Proposed Corriegarth 2 Wind Farm: Response to SEPA Consultation Request

Appendix A – Amended Figures

Corriegarth 2 Wind Farm

Peatland Condition Assessment
Post-Submission SEPA Amendment
Map 5

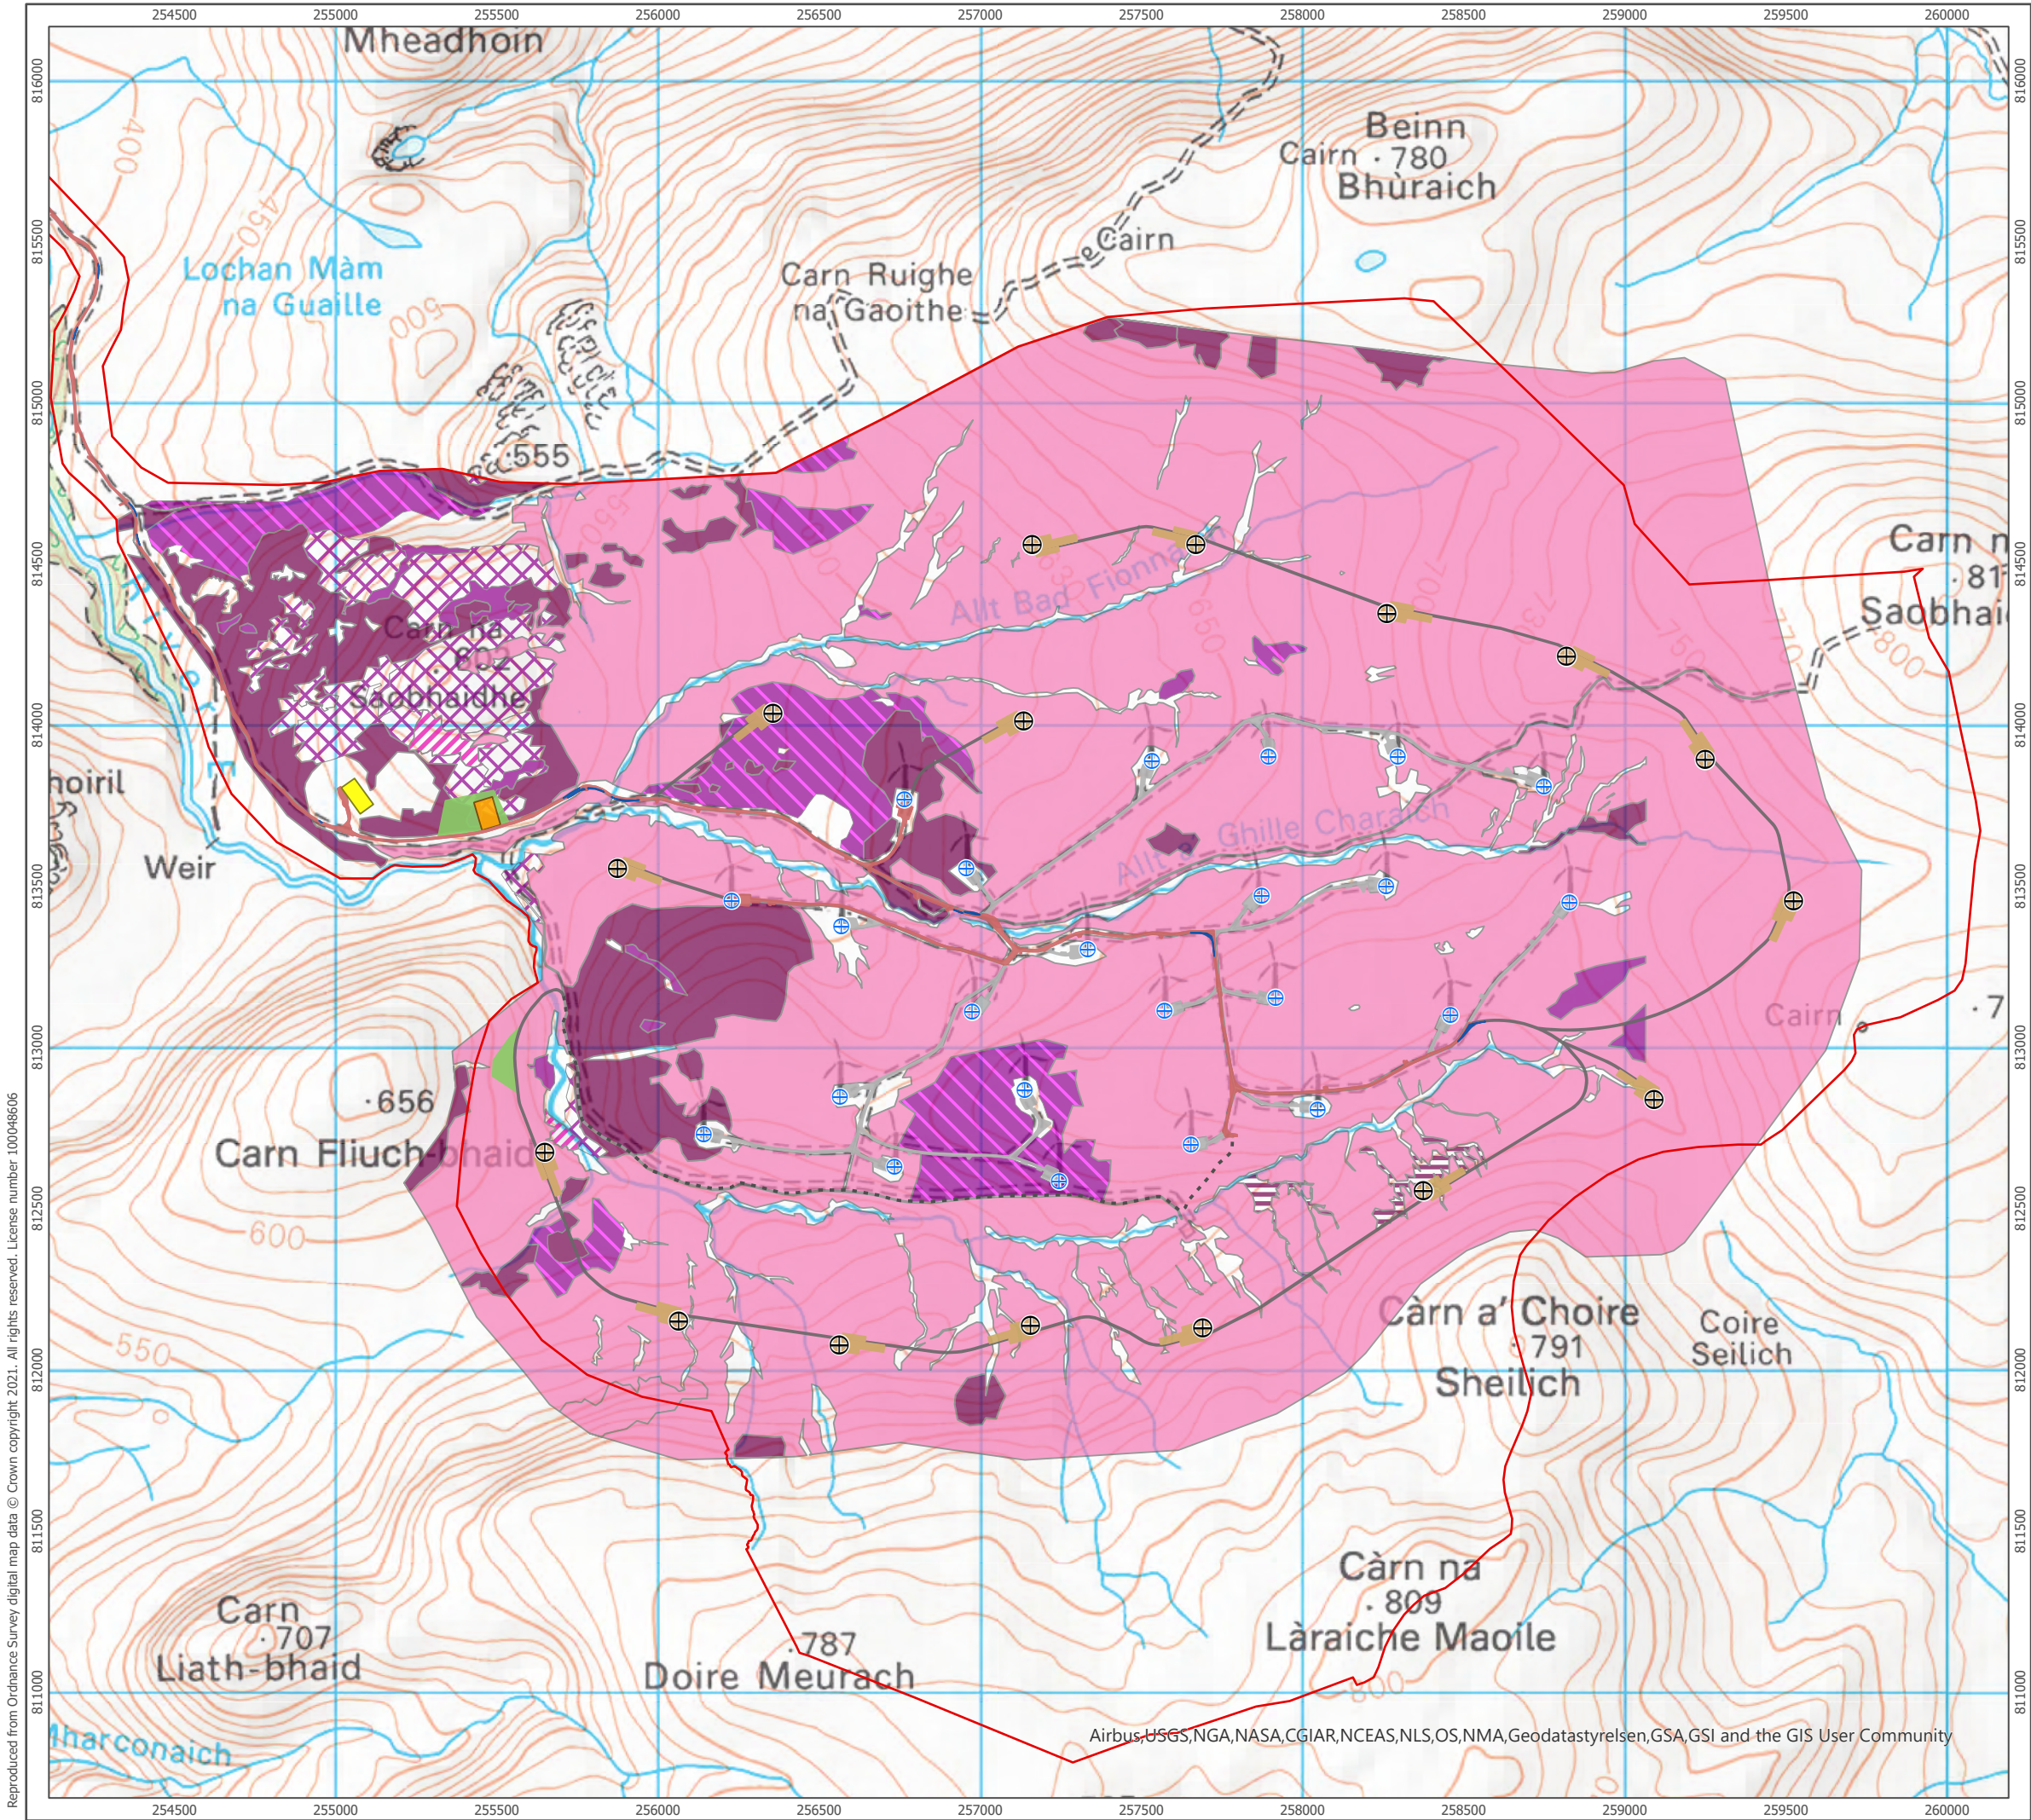
1. Figure 7.2 of Chapter 7: Ecology of the EIA Report is amended to include all proposed infrastructure associated with the Development (clearly marked);
2. All of the figures contained within Technical Appendix A7.1: Habitats and Botany Surveys to include all proposed infrastructure associated with the Development (clearly marked); and
3. Figure 13.2.2 of Technical Appendix A13.2: Outline Peat Management Plan to be provided on OS Basemapping; to be provided in a map series format; and with a revised symbology colour ramp.

2.	Appendix A7.2 was prepared prior to Development design freeze and its purpose was to inform the habitat baseline; ordinarily, figures within such a Technical Appendix would not include the Development design. However, following discussions between SEPA and Arcus (via telephone 06/07/2021), both parties have agreed that Arcus would provide updated figures to include Development design for the following Appendix A7.2 Maps; • Map 5: Peatland Condition Assessment; • Map 7: Guidance Groundwater Dependency; and • Map 9: Constraints. As A7.2 was prepared by an external party, updates to Maps 5, 7, & 9 will be presented on the Arcus template.
